Conflict analysis

Proposition baseline for Vacuum equipment layout in the TASX/P1 environment.

Analysis of the proposal presented on March 31st, 2015

Run configuration : conflict #2

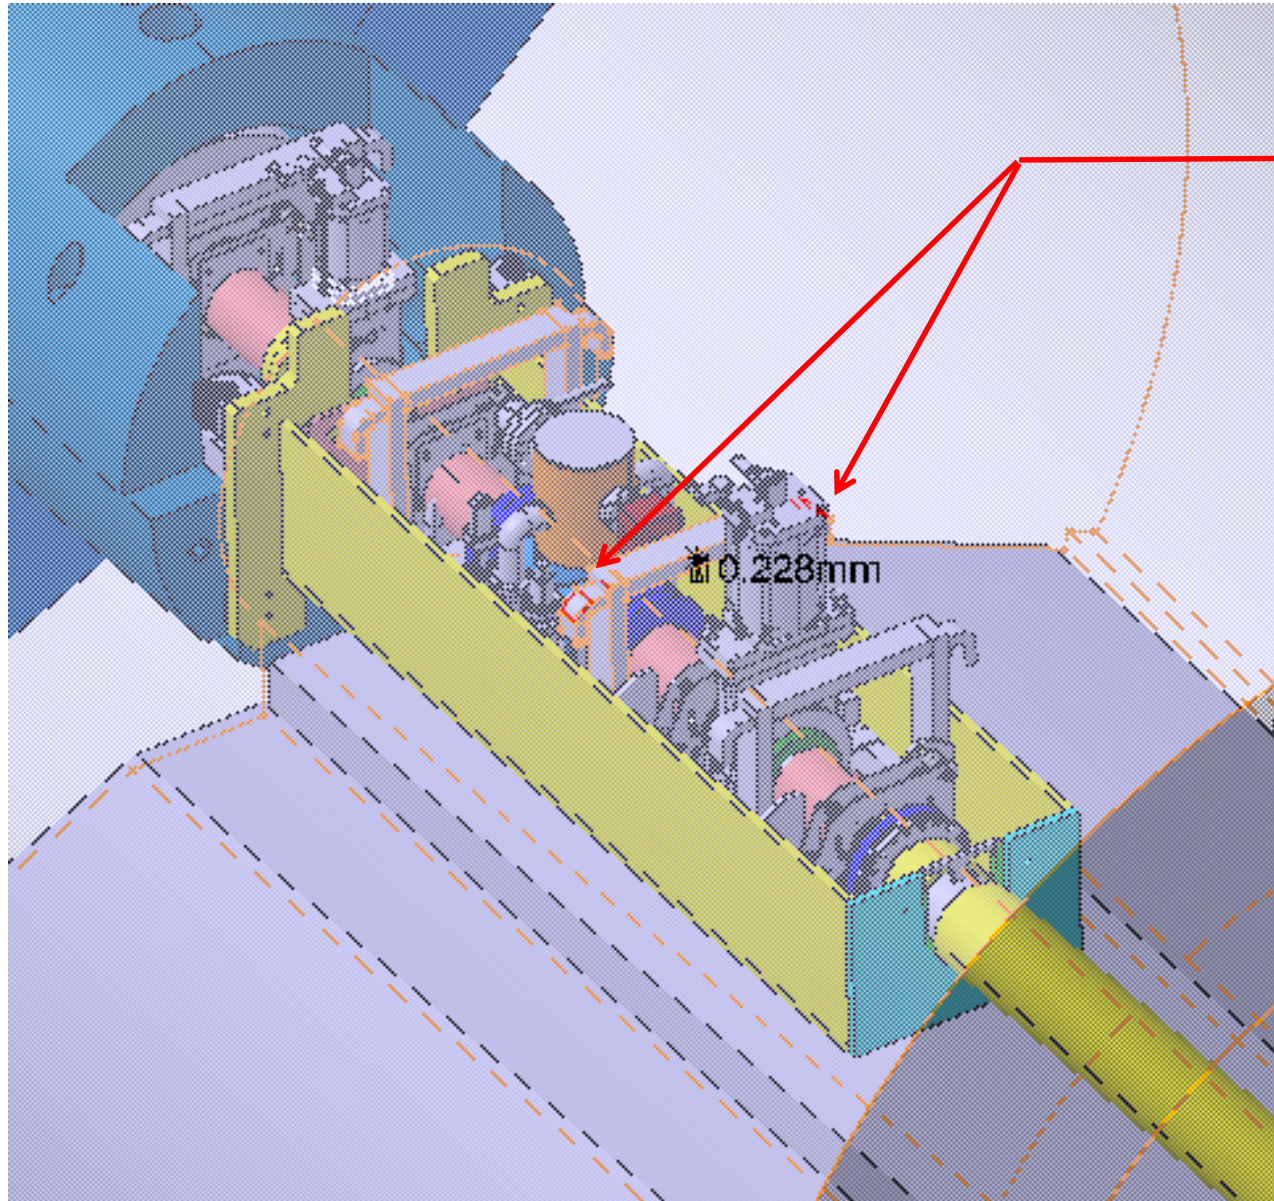
Lifting device enters JFC3
by about 10 mm

Run configuration : conflict #3

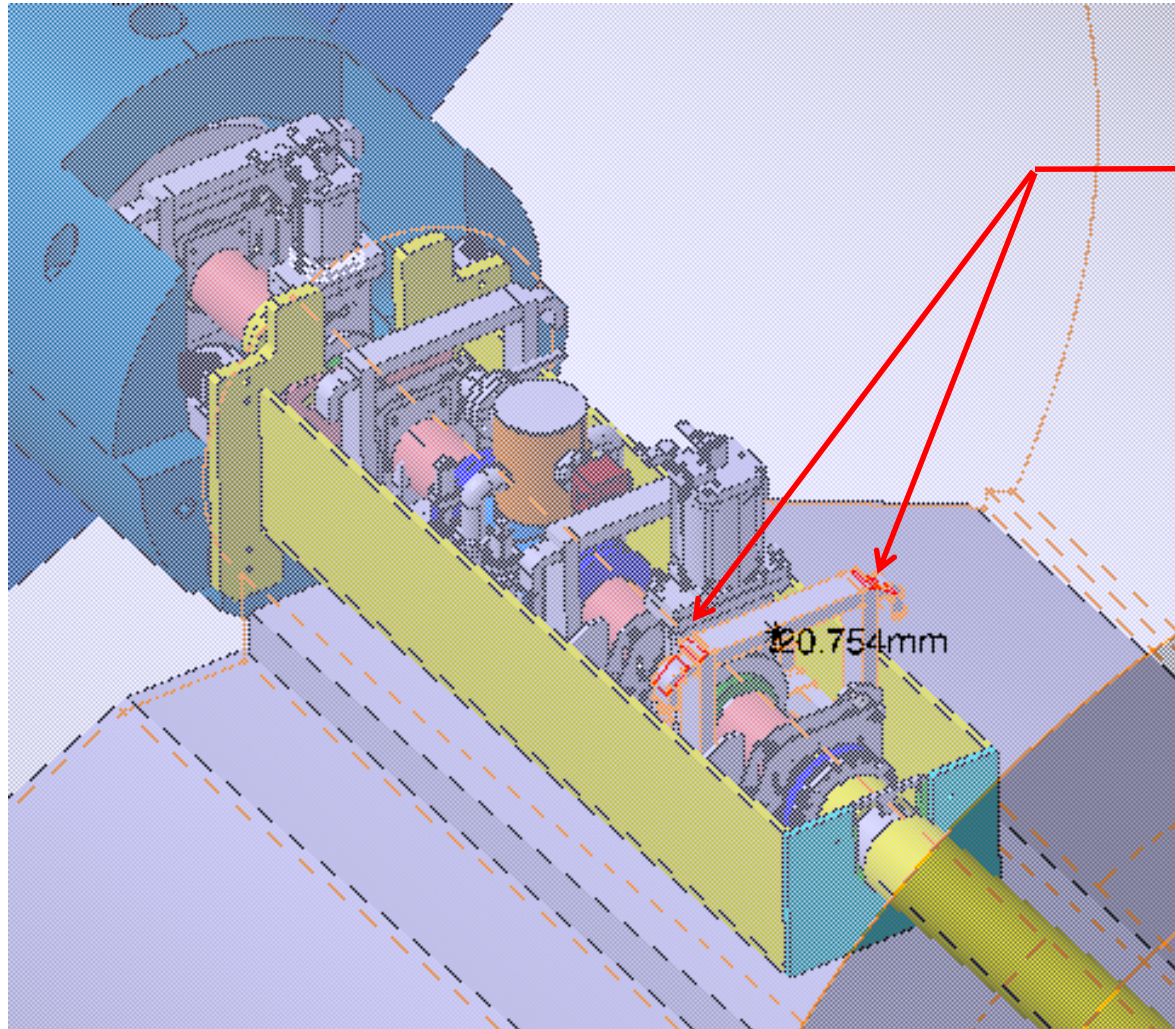
Lifting device enters JFC3
by about 20 mm

Elsewhere a **clearance of about 30 mm** is detected which is consistent with ATLAS policy regarding envelop.

Standard Opening configuration

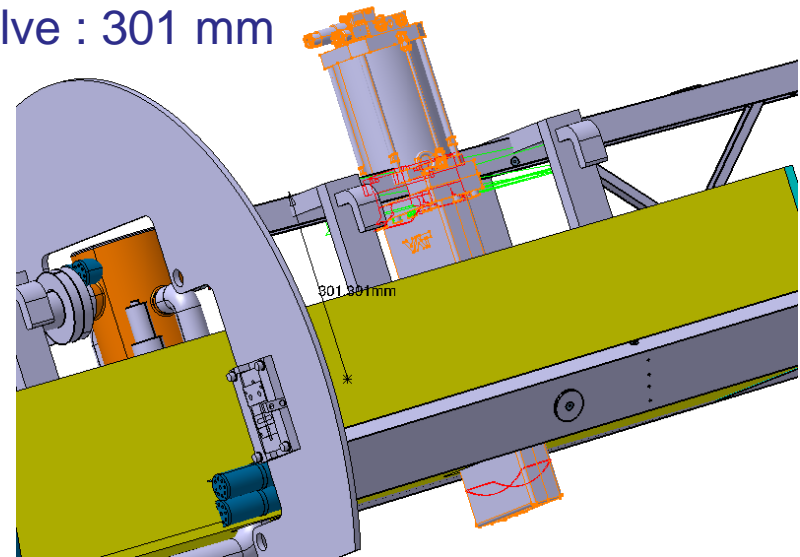
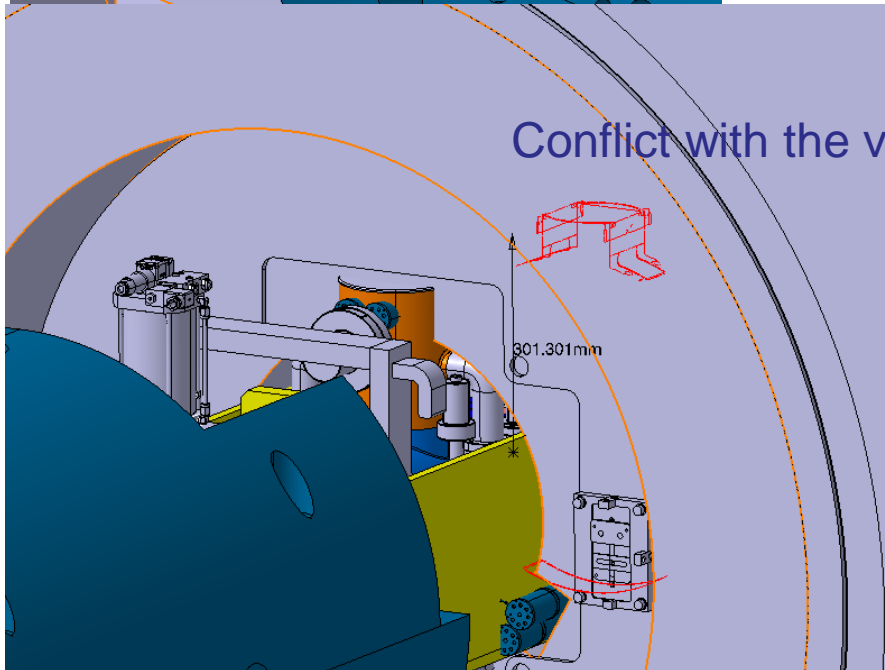
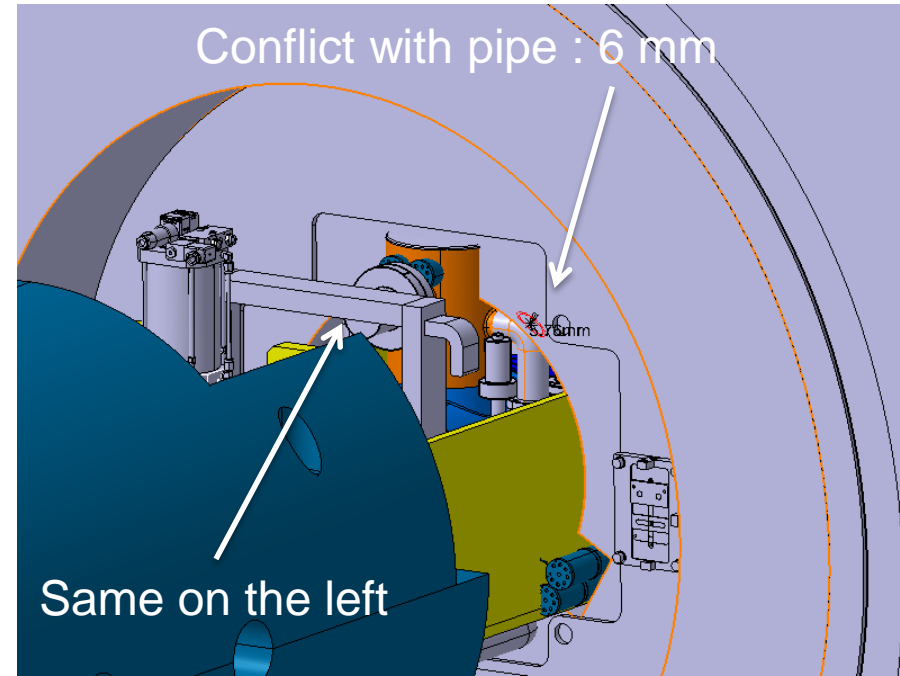
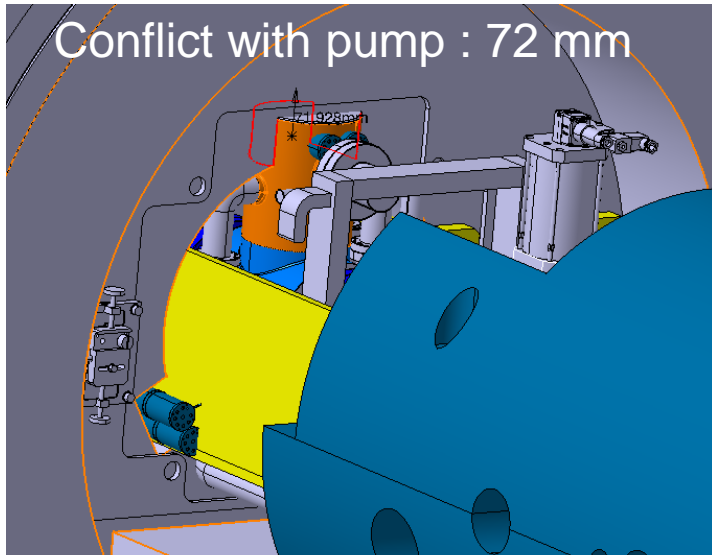
14 conflicts have been detected with ECT in the nominal position.

However, in order to take into account misalignment, re-positioning allowance and fabrication tolerances, it is mandatory to keep a clearance of 30 mm at least,

→ up to 28 the places are out of the criterion

65 conflicts have been detected with the vacuum chamber supports inside ECT.
